BRIEFING Videoconference 10:00 a.m.

1. 3000 MARTIN LUTHER KING JR. BLVD

James Madison High CA201-216(LC) Liz Casso

Figure 5 – View of the wood siding adjacent to a front entrance showing extensive moisture damage and material failure that significantly compromises the integrity of the exterior wall.

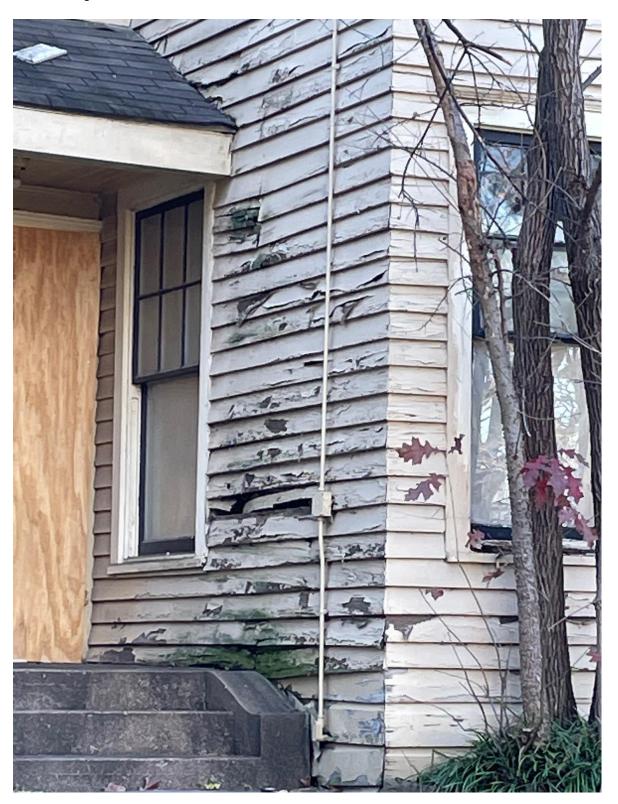
- a. Wood siding the siding appears to be in fair condition generally, however, this condition will not be fully known until examined from the interior surfaces. There is evidence of localized damage to the siding, such as the area impacted by water run-off from the entrance roof (Figure 5) and loss of fabric (Figures 8, 13, 14 and 15) that are considered to be in poor condition including areas that will require considerable repair or selective replacement.

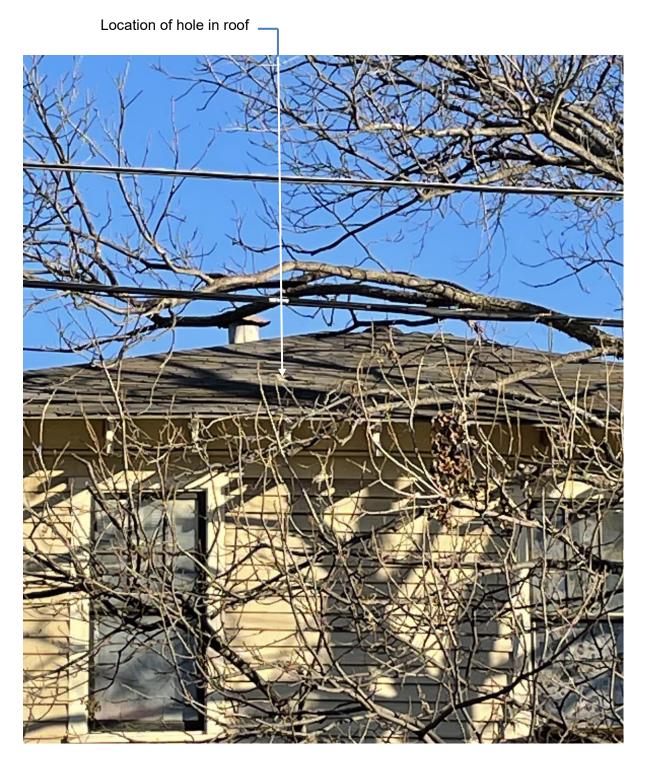
- e. Roof the roof shingles and plank sheathing, as evident from exterior and attic observations are subject to roof leaks. The hole in the roof (Figure 6) is perhaps the most adverse location for a compromised exterior envelope. While access to view the roof at close range was not practical, the localized damage visible from the street represents a critical area of the roof that is in **poor** condition.
